SUBJECT: 007999 – SR99 Bored Tunnel Alternative Design-Build Project
Federal-Aid No. BR-NH-STP-STPF-0099(111)
CO 172 – PCO 575, A.Way Restor-Const

**WASHINGTON STATE
DEPARTMENT OF TRANSPORTATION
CHANGE ORDER**

CONTRACT NO: 007999 FEDERAL AID NO: STP-ER-IM-0099 (11)
 CONTRACT TITLE: SR 99, BORED TUNNEL ALTERNATIVE - DESIGN BUILD PRO
 CHANGE ORDER NO: 172 PCO 575, A.WAY RESTOR-CONST

SR 99 TUNNEL PROJECT CONTRACT PACKAGE 14	R8552
STREET RESTORATION ROADWAY SECTIONS

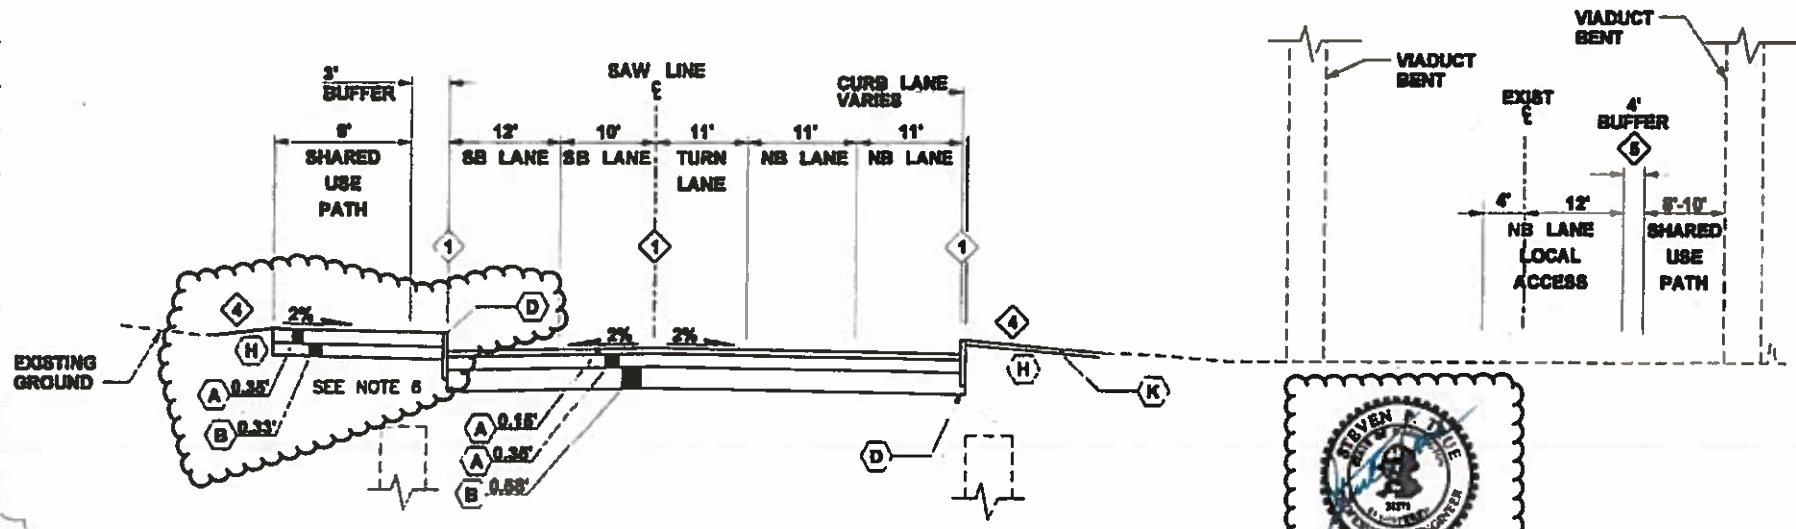
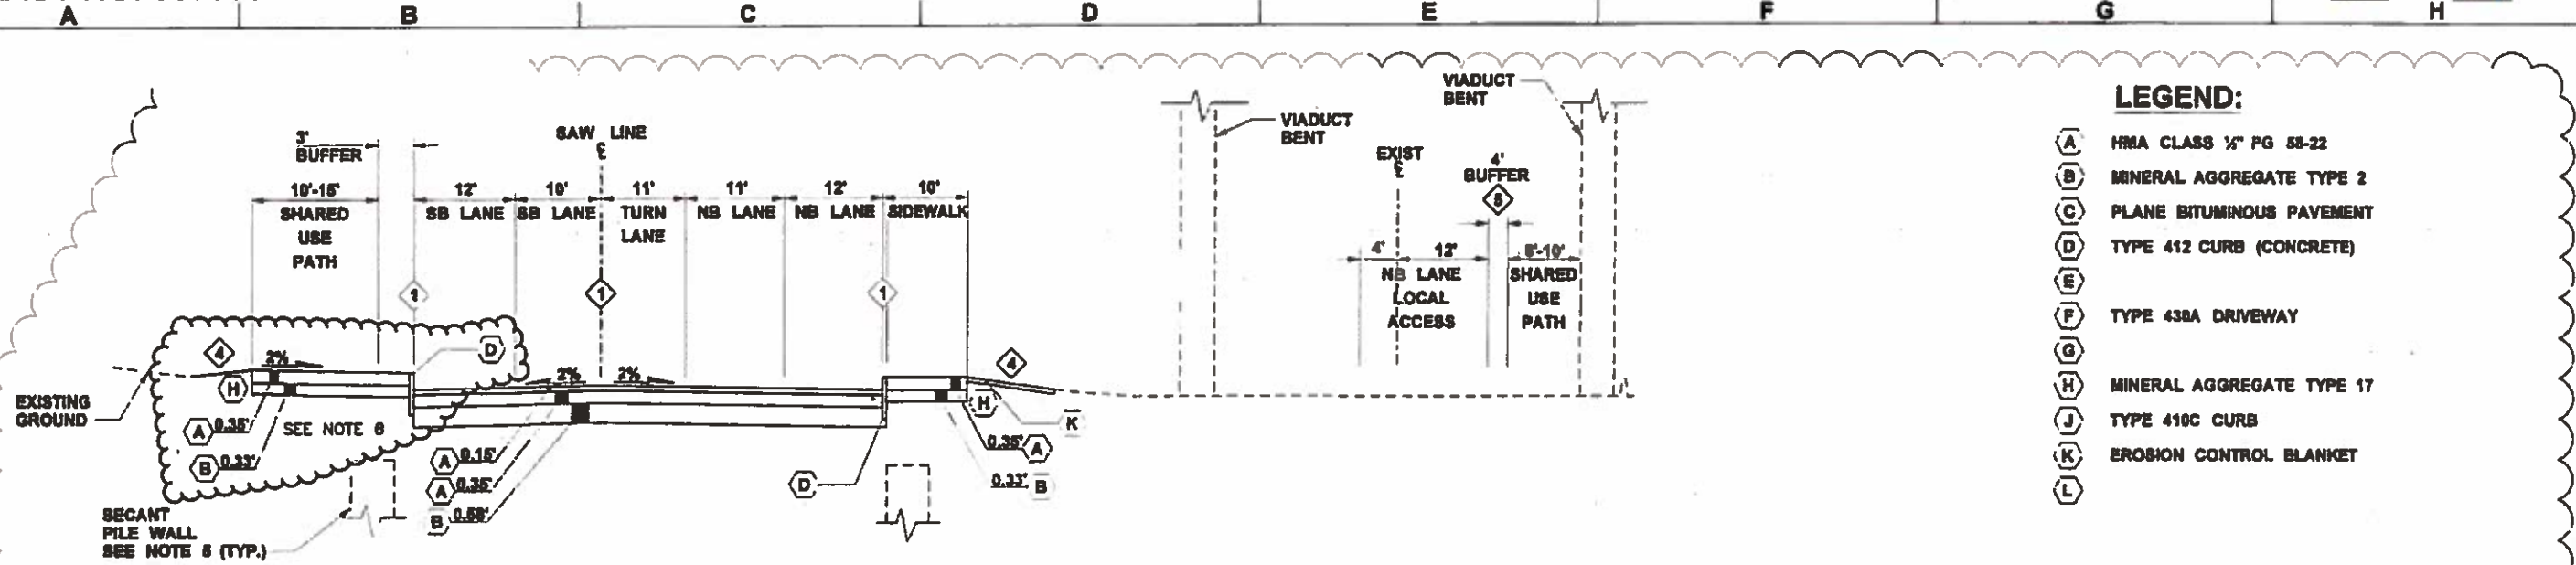
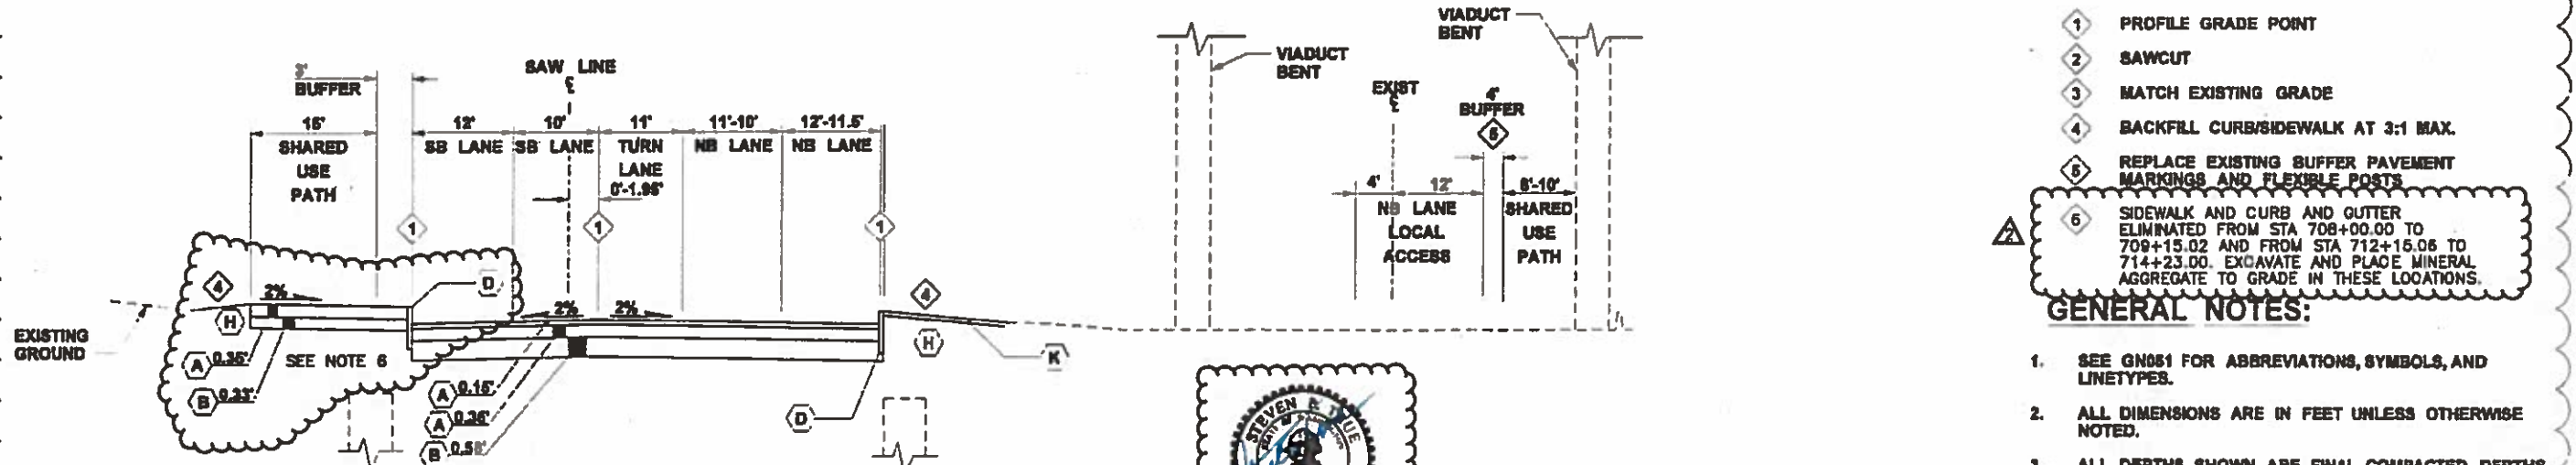
- 1 PROFILE GRADE POINT
- 2 SAWCUT
- 3 MATCH EXISTING GRADE
- 4 BACKFILL CURB/SIDEWALK AT 3:1 MAX.
- 5 REPLACE EXISTING BUFFER PAVEMENT MARKINGS AND FLEXIBLE POSTS
- 6 SIDEWALK AND CURB AND GUTTER ELIMINATED FROM STA 707+88.77 TO 708+00.00. EXCAVATE AND PLACE MINERAL AGGREGATE TO GRADE IN THIS LOCATION.

REVISION	DATE	BY
RF1-04147	01/05/2018	ST
NDC 085 - STREET RESTORATION MODIFICATIONS	08/08/2017	RIK

ROADWAY SECTION G

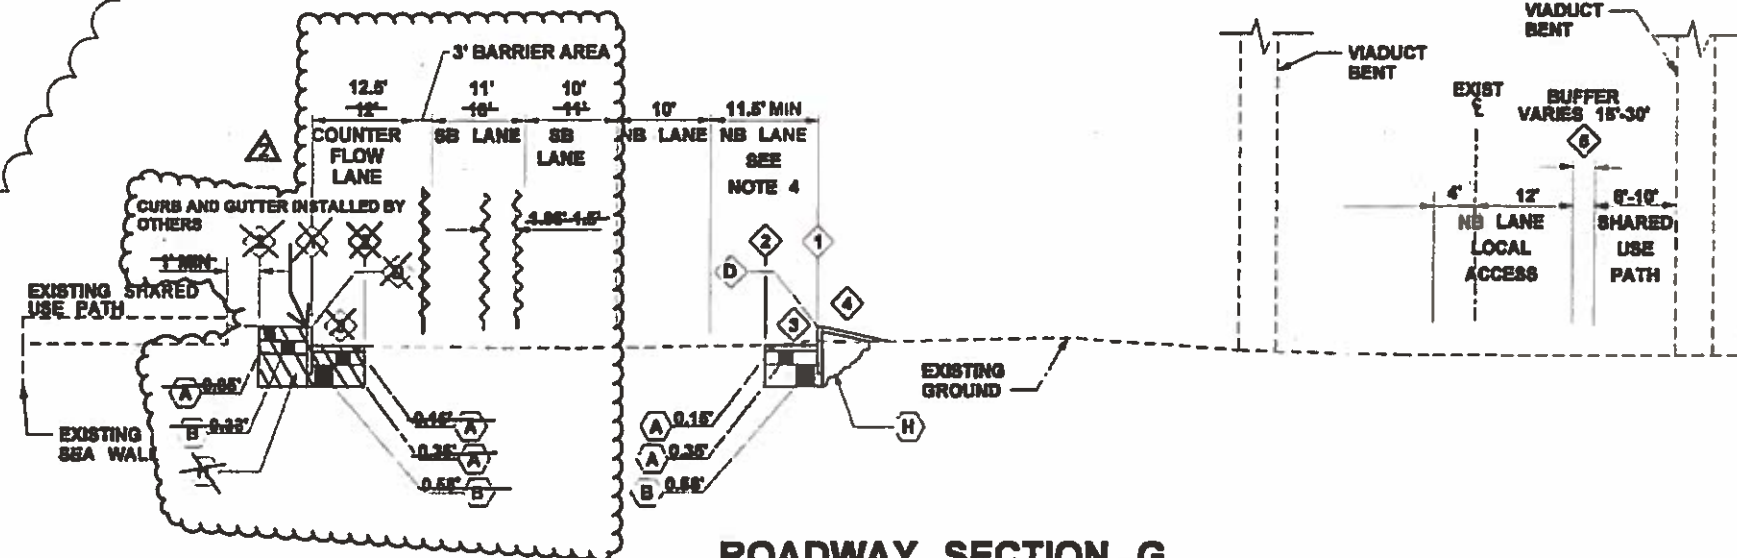
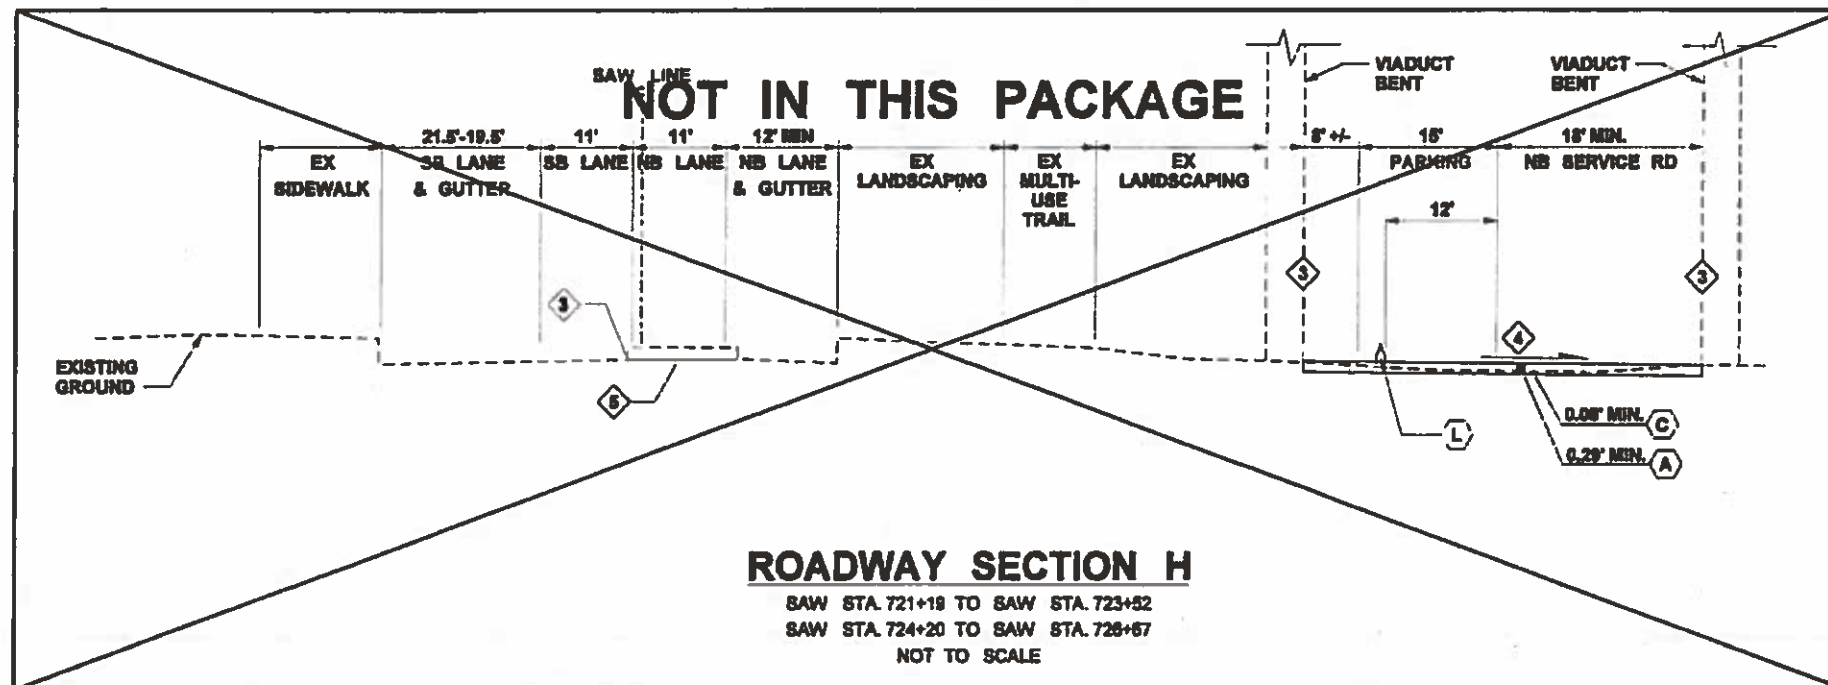
- 1 PROFILE GRADE POINT
- 2 SAWCUT
- 3 MATCH EXISTING GRADE
- 4 BACKFILL CURB/SIDEWALK AT 3:1 MAX.
- 5 REPLACE EXISTING BUFFER PAVEMENT MARKINGS AND FLEXIBLE POSTS
- 6 SIDEWALK AND CURB AND GUTTER ELIMINATED FROM STA 708+00.00 TO 709+15.02 AND FROM STA 712+15.06 TO 714+23.00. EXCAVATE AND PLACE MINERAL AGGREGATE TO GRADE IN THESE LOCATIONS.

SR 99 TUNNEL PROJECT
CONTRACT PACKAGE 14
AL153
STREET RESTORATION
ALIGNMENT AND PAVING PLAN

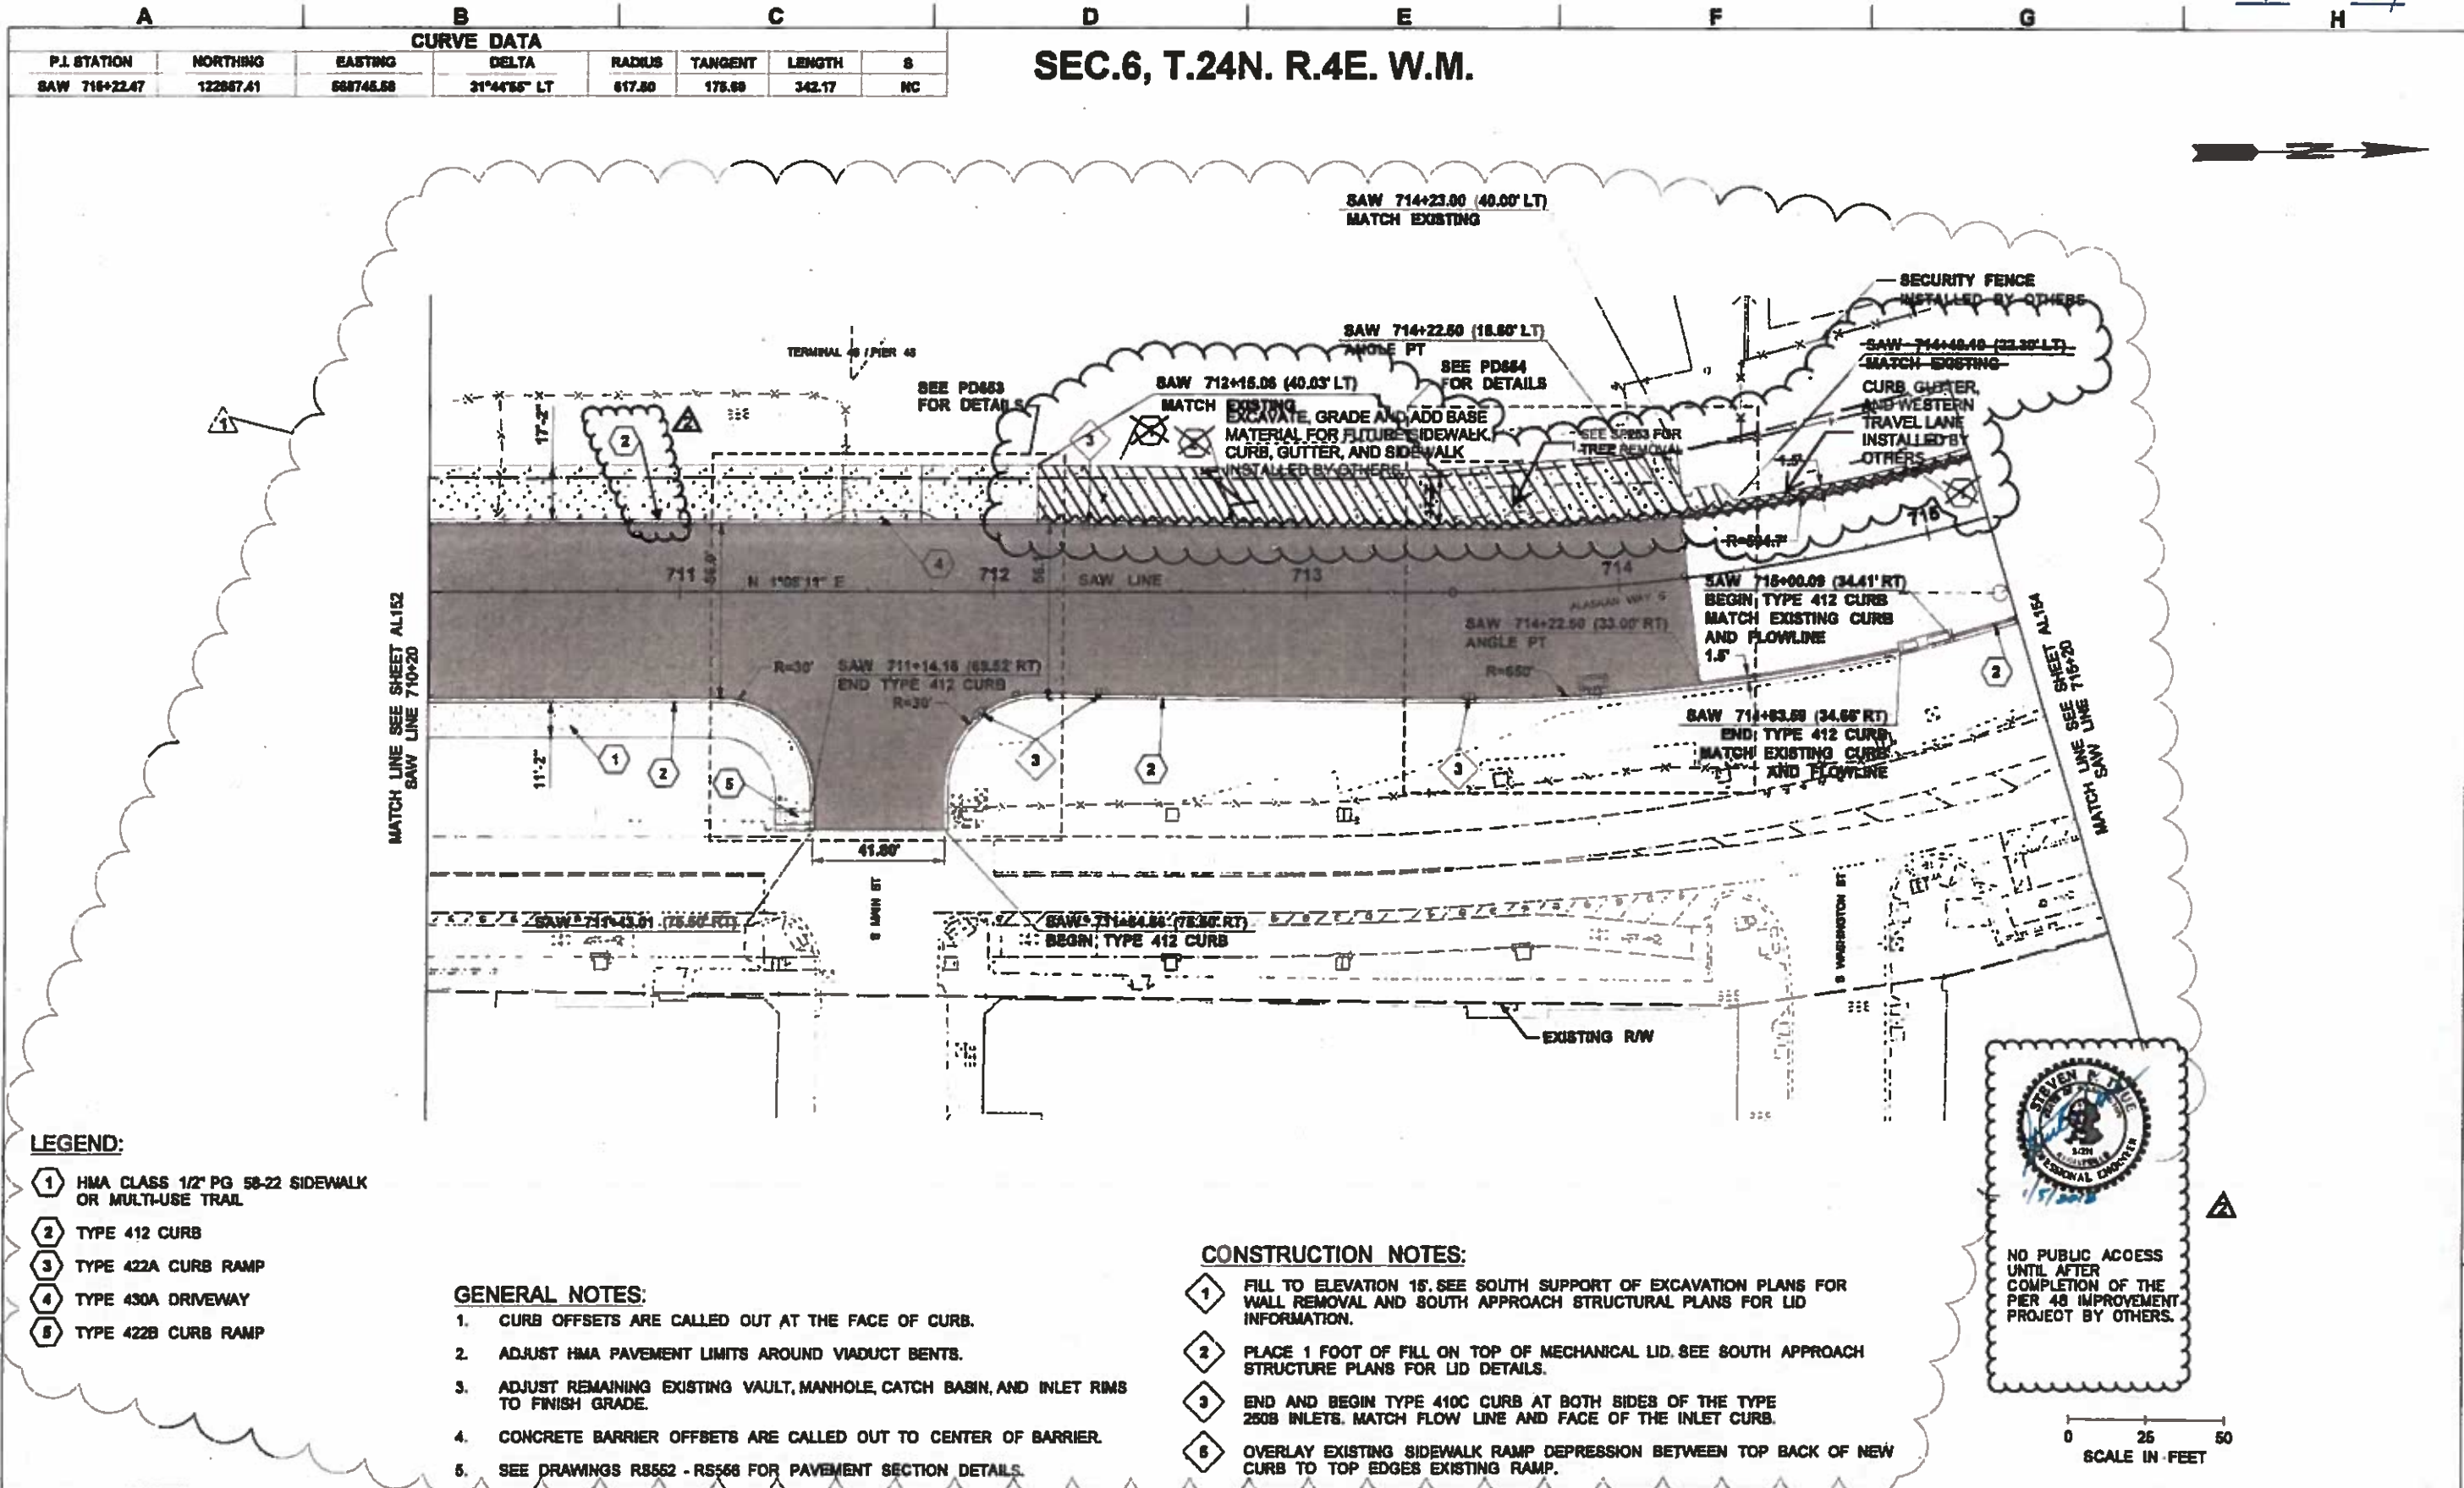
FILE NAME	XL7999-ALL-14AL153.dwg		ASSIGN NO.	10	STATE	WASH	FED.AID PROJ.NO.	BR-0099(111)	
TIME	1:56:33 PM		JOB NUMBER			CONTRACT NO.			
DATE	10/10/2017		DATE	01/08/2018	BY	ST			
PLOTTED BY	mmorford		REVISION	MDC 085 - STREET RESTORATION MODIFICATIONS		DATE	08/08/2017		
DESIGNED BY	E. EVANS		BY	L. LAIRD		DATE			
ENTERED BY	D. BRINKMANN		DATE			BY			
CHECKED BY	R. KITTLER		DATE			BY			
PROJ. ENGR.	R. JOHNSON		DATE			BY			
REGIONAL ADM.	L. LAIRD		DATE			BY
